PIC12F508/509 Rev. B0 Silicon/Data Sheet Errata

The PIC12F508/509 parts you have received conform functionally to the Device Data Sheet (DS41236E), except for the anomalies described below.

FIGURE 1:

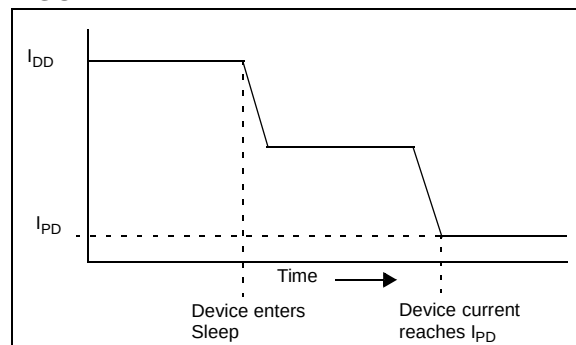
3. Module: I_{PD}, Power-Down Base Current

On the PIC12F508/509 silicon, revisions earlier than A3, the power-down base current may remain higher than the specification for a short time when entering Sleep.

The following graph illustrates the device current upon entering Sleep:

The length of time between the device entering Sleep mode and the device current reaching I_{PD} increases as both temperature and voltage decrease.

This issue is fixed in Revisions A3 and later.
